INSPECTION REPORT

I arrived at the Canyon View – 7-Eleven site (“Site” or “Facility”), located at 19011 141st Street CT E, Bonney Lake, Washington, at 10:05 AM (PT) on 04/13/2023 for an unannounced inspection. I presented my credentials to Mr. Bobby Pedersen, Site Superintendent, and informed him I was there to conduct an inspection to determine compliance with the Clean Water Act (CWA) and the Washington Department of Ecology (WDOE) Construction Stormwater General Permit. (CGP). This report is based on information supplied by Mr. Pedersen, direct observations made by me, and records and reports maintained by the permittee. In addition, information gathered prior to, or after, the inspection from a review of EPA, State, and/or public records may be included in this report.

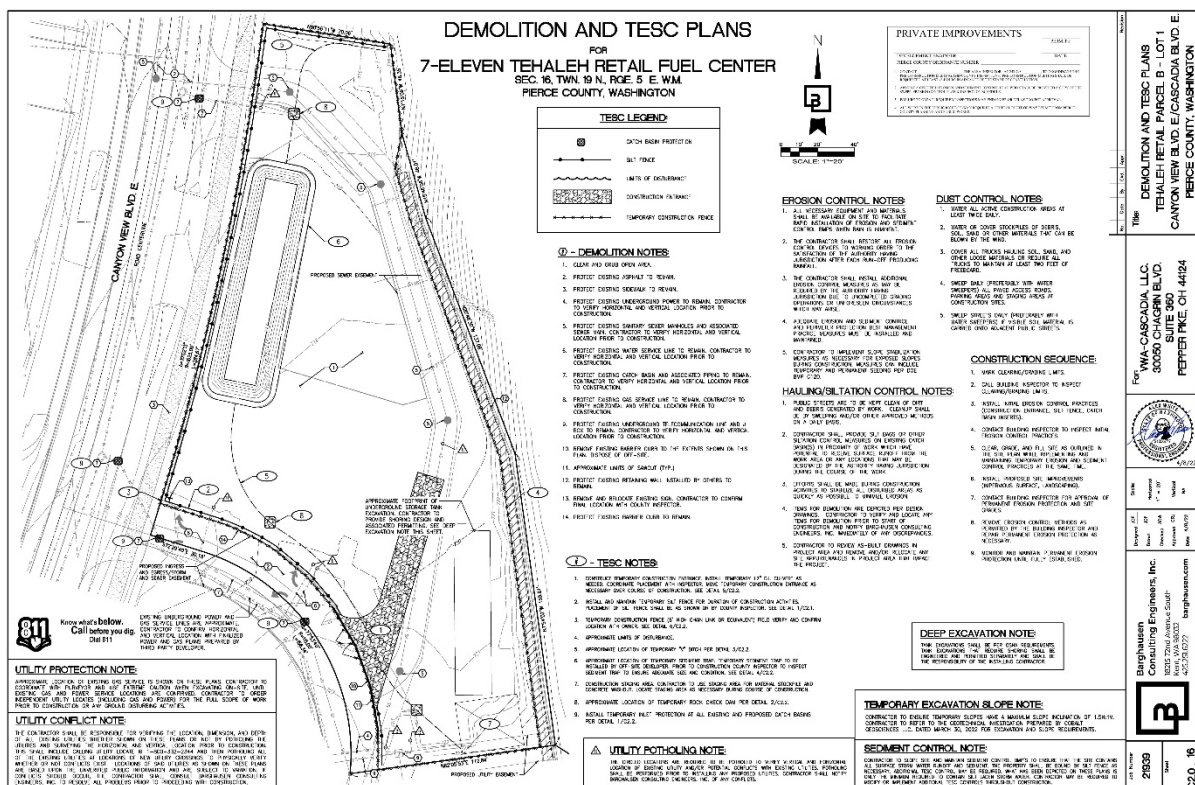
Record: Other - Stormwater Pollution Prevention Plan (SWPPP) Map		AOC: Yes
Ref #: RA1-RR-004	Reviewed By: Raymond Andrews	Reviewed Date: 06/15/2023
At the time of the inspection, I reviewed the site's SWPPP map. The site was using the Demolition and Temporary Erosion and Sediment Control (TESC) Plans, dated April 8, 2022, as the site map. The site map did not include the direction of stormwater flow, or location of sampling stations as required by the permit.		
Record: Other - Construction Stormwater Site Inspection Form		AOC: No
Ref #: RA1-RR-003	Reviewed By: Raymond Andrews	Reviewed Date: 04/13/2023
At the time of inspection, I reviewed a Construction Stormwater Site Inspection Form, dated March 31, 2023. The inspection was conducted by Bobby Pedersen, the Certified Erosion and Sediment Control Lead (CESCL).		
The form is complete, signed and dated and no issues were noted.		
Record: Other - Partial Coverage Transfer Letter		AOC: No

AOC Reference #: RA1-RR-004	Records Review: Other - Stormwater Pollution Prevention Plan (SWPPP) Map
Permit Requirement	
Permit Part S9.E , "The SWPPP must also include a legible site map (or maps) showing the entire construction site. The following features must be identified, unless not applicable due to site conditions... 3. Approximate slopes, contours, and direction of stormwater flow before and after major grading activities... 9. Location of water quality sampling station(s), if sampling is required by state or local permitting authority."	
AOC:	
The site map did not include the direction of stormwater flow, or location of sampling stations as required by the permit. A copy of the site map, provided by Saybr Contractors, is shown below.
